Thornhill Park Catholic Primary School and Early Learning Centre

64 Wiltshire Boulevard, Thornhill Park
PA2403034

Officer Assessment Report
Development Approvals & Design

Department
of Transport
and Planning

Figure 2 proposed masterplan

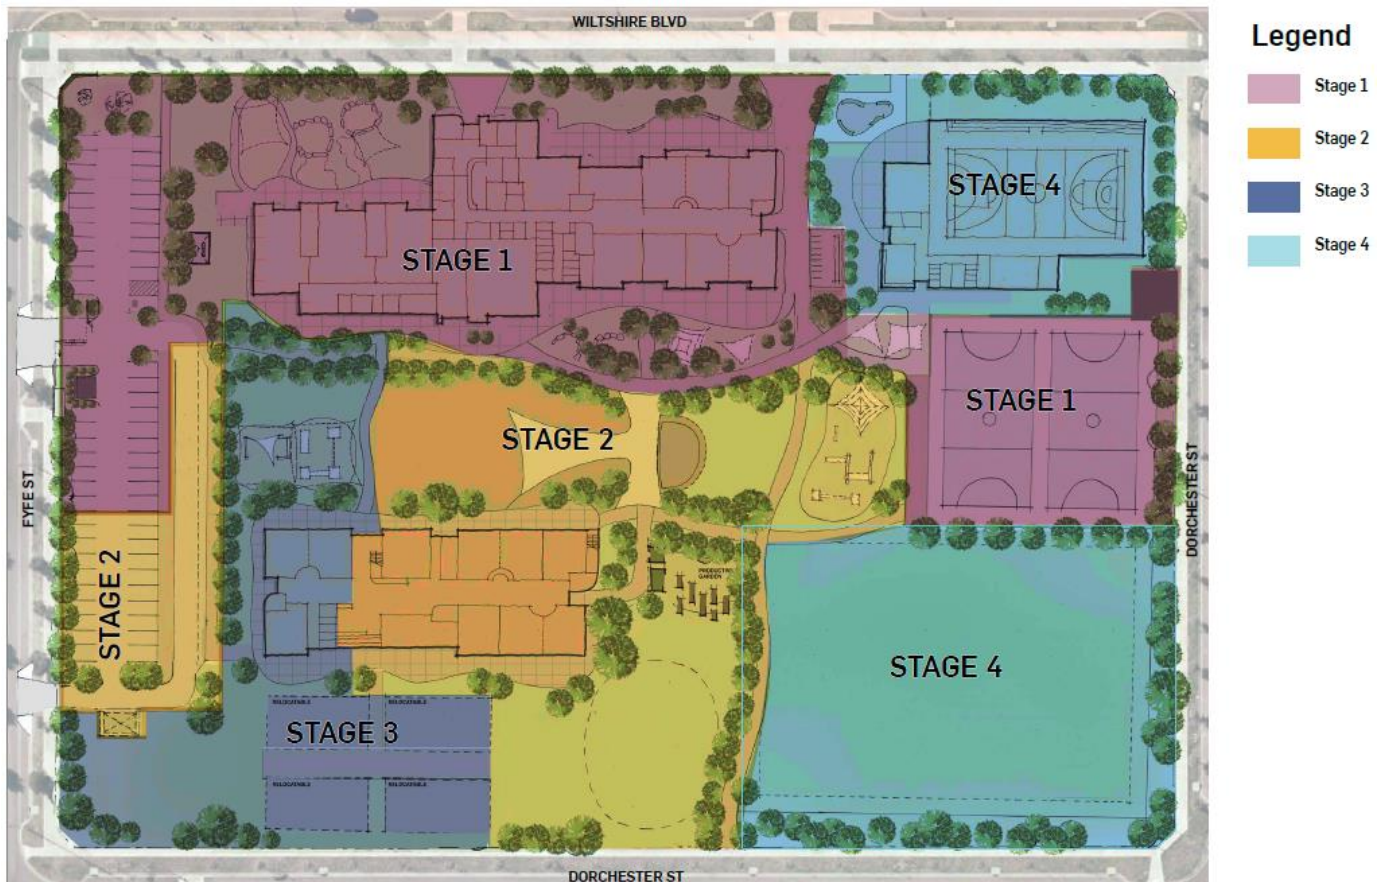
64. The masterplan does not show the height of relocatable buildings to the south within Stage 3. It is noted that Clause 62.02-1 specifies buildings and works not requiring a permit includes a temporary portable classroom associated with an education centre located on a site for three years or less. It is not clear how long the relocatable buildings will be in place for and therefore considered that the masterplan should depict heights for this built form.
